Name Of Dam: LAKELAND
Location: CAMPBELL COUNTY.
Inventory Number: VA 03111

PHASE I INSPECTION REPORT
NATIONAL DAM SAFTY PROGRAM

REPORT DOCUMENTATION PAGE		READ INSTRUCTIONS BEFORE COMPLETING FORM
1. REPORT NUMBER	2. GOVT ACCESSION NO. AD A103 517	3. RECIPIENT'S CATALOG NUMBER
4. TITLE (and Subtitle) Phase I Inspection Report National Dam Safety Program National Dam Safety Program, Lakeland Dam (Inventory Number VA-03111), James River Basin, Campbell County, Virginia. Phase I Inspection Report.		5. TYPE OF REPORT & PERIOD COVERED Final

LAKELAND DAM
CAMBELL COUNTY
8 OCTOBER 1980
PLATE II

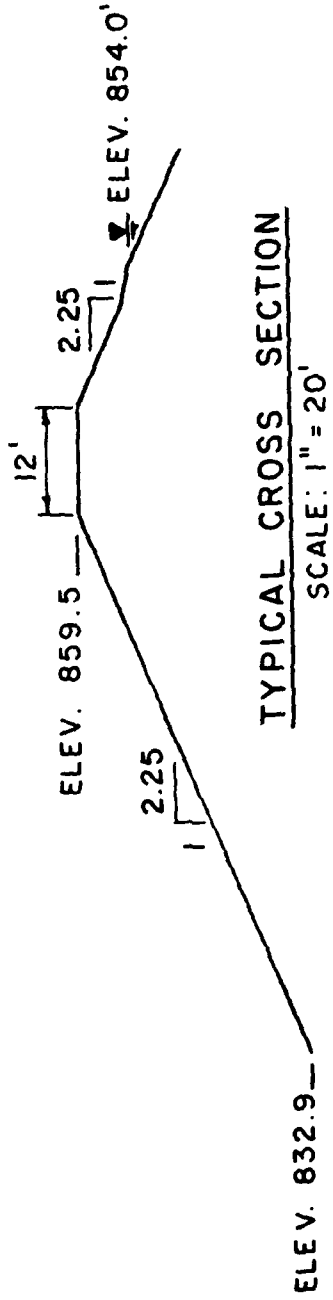
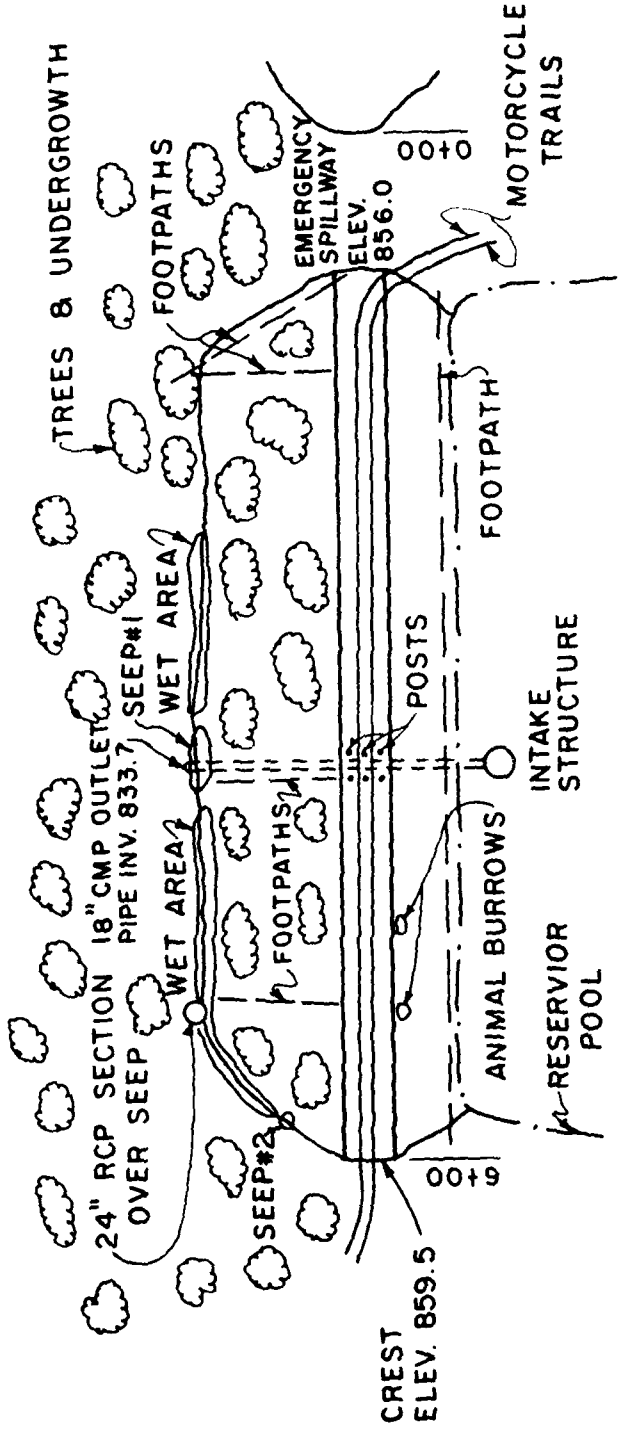
There are no signs of surface cracks, unusual movement or misalignment. However, there are two animal burrows located on the upstream face of the dam (See Plate II, Appendix I) at station 4+50 and 5+00. The burrow at station 4+50 is about 8 inches in diameter and over 4 feet deep. There is a local sloughing of material around the burrow. The burrow at station 5+00 is much smaller. Two motorcycle trails run up the upstream right abutment, cross the crest and continue up the left abutment. A foot path runs along the waterline on the upstream face and several footpaths run down the downstream face from the crest to the toe.

a. The animal burrows should be filled with compacted material, the surrounding area dressed and seeded.
